11 August 2006

Docket No.: 71-9027  
TAC Nos. L23922, L23895 and L23896

Subject: Additional Supportive Information for the Model 741-OP Type B Container

TITLE		MODEL 741-OP	
SIZE	DWG. NO.	R741-OP	REV
A	SCALE: NONE	SHEET 1 OF 7	D

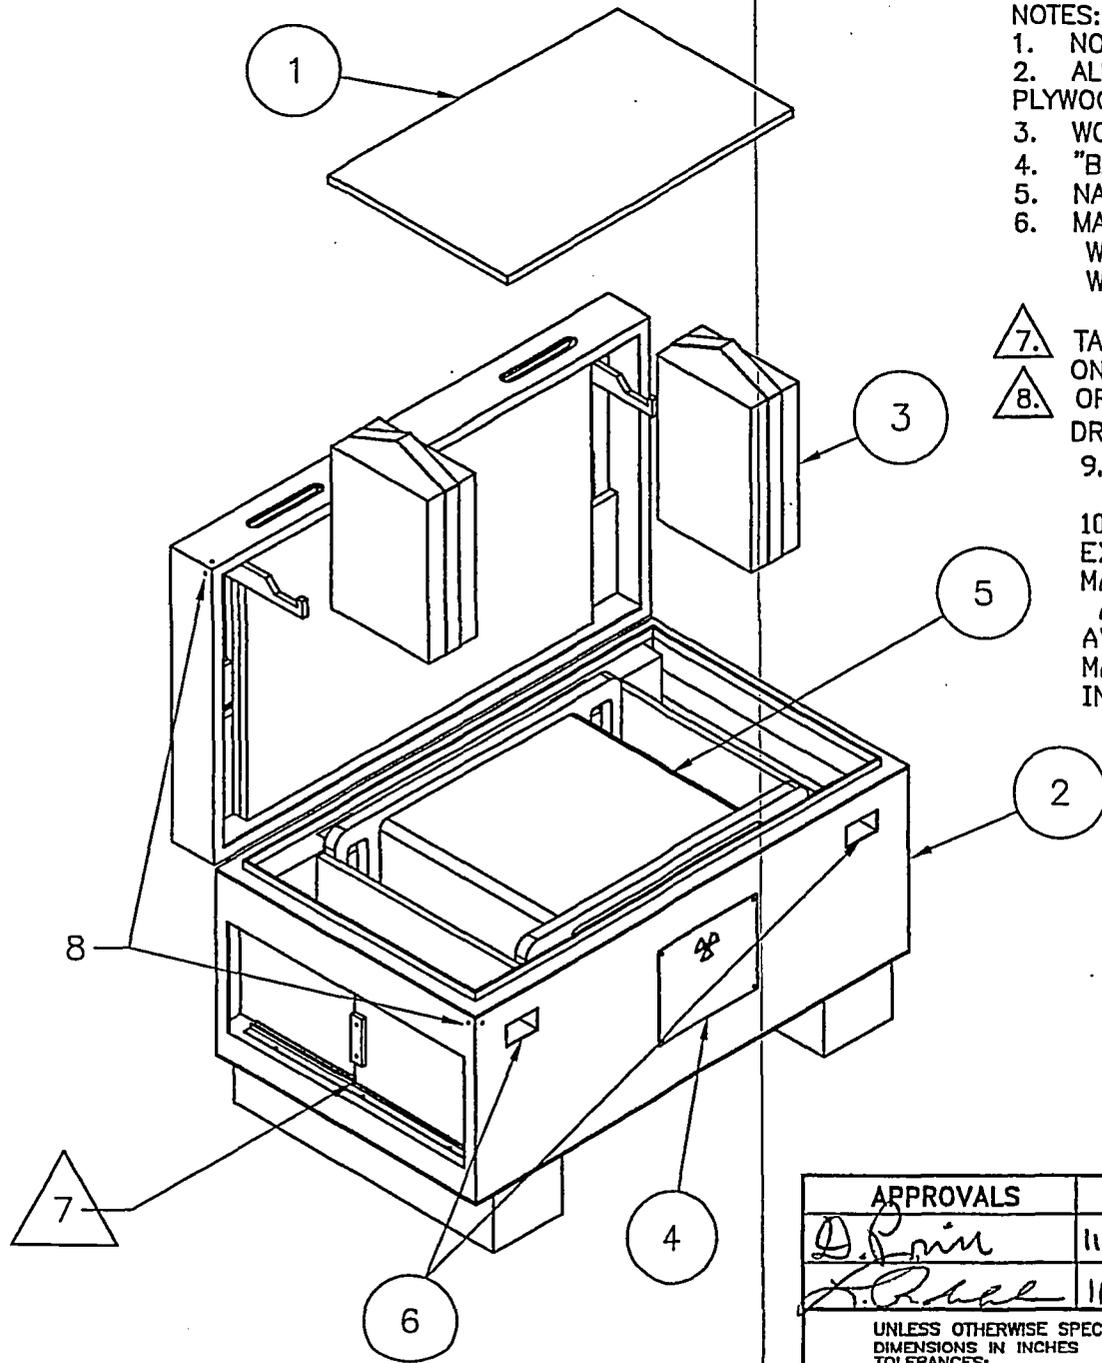
- Drawing R741-OP Revision D is enclosed to correct the device referenced in Item 5 on sheet 1 of that drawing.
- Section 8.1.5 is modified to incorporate the lock assembly component test as requested by your staff.

ITEM	QTY.	DESCRIPTION
6	2	PADLOCK
5	1	741 PROJECTOR PER R74190
4	1	NAME PLATE, STEEL, FIRE PROOF
3	2	WOOD BLOCK INSERTS (SHEET 3)
2	1	OVERPACK, 16 ga CRS FEET 13 ga CRS
1	1	WOOD SUPPORT BASE, 3/4 THICK
